DEVELOPMENT APPLICATION ASSESSMENT REPORT

Application Number:	DA2023/1678
Responsible Officer:	Simon Ferguson Tuor
Land to be developed (Address):	Lot 12 DP 758044, 1 Cutler Road CLONTARF NSW 2093
Proposed Development:	Alterations and additions to a dwelling house including a swimming pool
Zoning:	Manly LEP2013 - Land zoned C3 Environmental Management
Development Permissible:	Yes
Existing Use Rights:	No
Consent Authority:	Northern Beaches Council
Land and Environment Court Action:	No
Owner:	Robert William Joyce Christina Grace Allen
Applicant:	Megan Janet McGlinchey

Figure 1: Height of Building variation shown in red

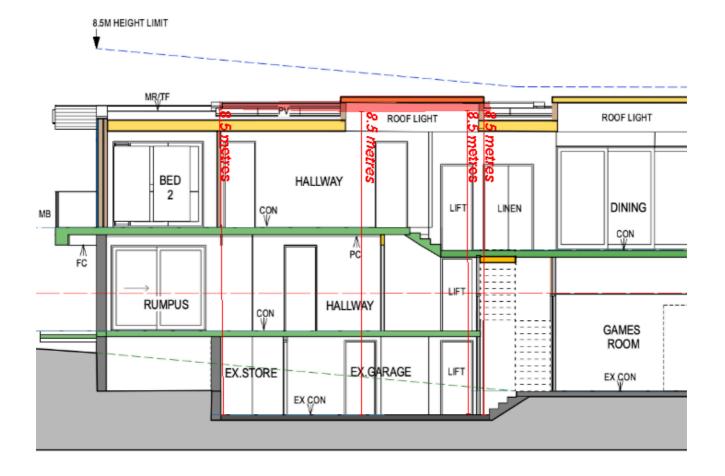
Sufficient environmental planning grounds exist to justify the height of buildings variation includes the artificially modified topography of the land which makes strict compliance difficult to achieve whilst distributing height and floor space in a contextually appropriate manner on this particular site. In this regard, I note that the prior disturbed levels of the site within the lower level garage distorts the height of buildings development standard plane overlaid above the site when compared to the natural undisturbed topography of the land. When the original undisturbed levels of the site are interpolated across the building footprint the proposed development would comply with the 8.5 metre height standard. Consistent with the finding of O'Neill C at paragraph 73 of Merman Investments Pty Ltd v

Woollahra Municipal Council [2021] NSWLEC 1582 such circumstance can properly be described as an environmental planning ground within the meaning of cl 4.6(3)(b) of LEP 2014.

Council's Planning Assessment Officer concurs with the applicant's justification.
